Devon Energy Production Co., L.P. respectfully requests to change the casing design of the production string to a combo 7" x 5-1/2" string and utilize a multibowl wellhead.

Ragin Cajun 14 Fed 1H – APD DRILLING PLAN  
KKS 8-27-2013

PECOS DISTRICT  
CONDITIONS OF APPROVAL

OPERATOR'S NAME:	Devon Energy Production Company, L.P.
LEASE NO.:	NMNM-94118
WELL NAME & NO.:	Ragin Cajun 14 Federal 1H
SURFACE HOLE FOOTAGE:	0330' FSL & 0330' FEL
BOTTOM HOLE FOOTAGE	0990' FSL & 0330' FEL Sec. 11, T. 26 S., R 34 E.,
LOCATION:	Section 14, T. 26 S., R 34 E., NMPM
COUNTY:	Lea County, New Mexico

DRAWING NUMBER  
**DM100161771-2A**

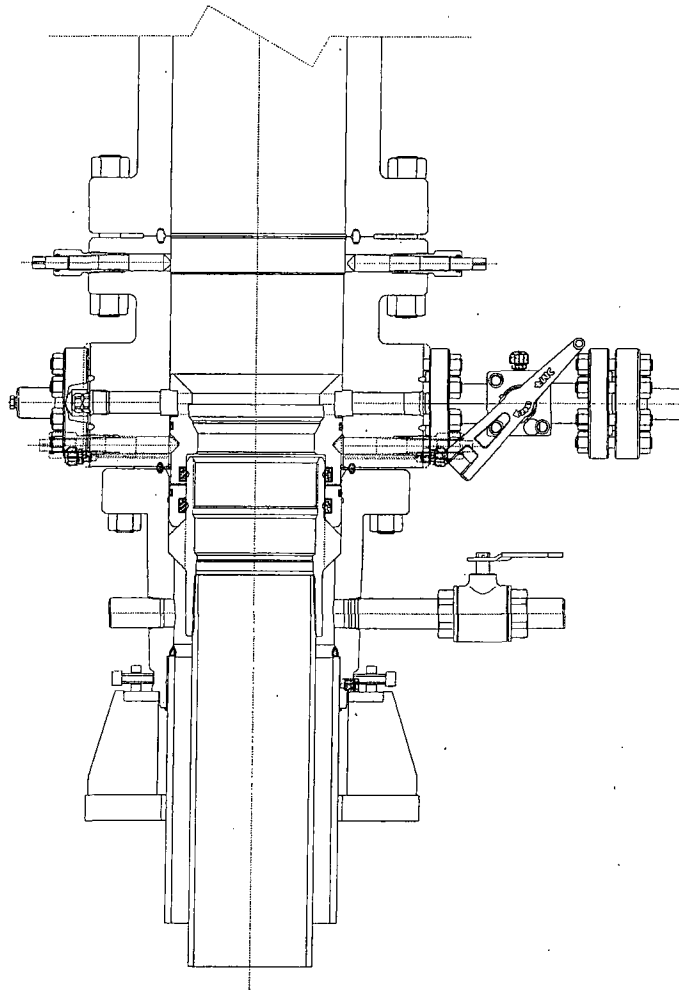
Devon proposes using a multi-bowl wellhead assembly (FMC Uni-head). This assembly will only be tested when installed on the surface casing. Minimum working pressure of the blowout preventer (BOP) and related equipment (BOPE) required for drilling below the surface casing shoe shall be ~~5000 (SM)~~ **3,000 psi (3m)**

- Wellhead will be installed by FMC's representatives.
- If the welding is performed by a third party, the FMC's representative will monitor the temperature to verify that it does not exceed the maximum temperature of the seal.
- FMC representative will install the test plug for the initial BOP test.
- FMC will install a solid steel body pack-off to completely isolate the lower head after cementing intermediate casing. After installation of the pack-off, the pack-off and the lower flange will be tested to ~~SM~~ **3m**, as shown on the attached schematic.

Everything above the pack-off will not have been altered whatsoever from the initial nipple up. Therefore the BOP components will not be retested at that time.

3. **Operator has proposed a multi-bowl wellhead assembly. This assembly will only be tested when installed on the surface casing. Minimum working pressure of the blowout preventer (BOP) and related equipment (BOPE) required for drilling below the surface casing shoe shall be 3000 (3M) psi.**

- a. Wellhead shall be installed by manufacturer's representatives, submit documentation with subsequent sundry.
  - b. If the welding is performed by a third party, the manufacturer's representative shall monitor the temperature to verify that it does not exceed the maximum temperature of the seal.

- c. Manufacturer representative shall install the test plug for the initial BOP test.
  - d. Operator shall perform the intermediate casing integrity test to 70% of the casing burst. This will test the multi-bowl seals.

- e. If the cement does not circulate and one inch operations would have been possible with a standard wellhead, the well head shall be cut off, cementing operations performed and another wellhead installed.
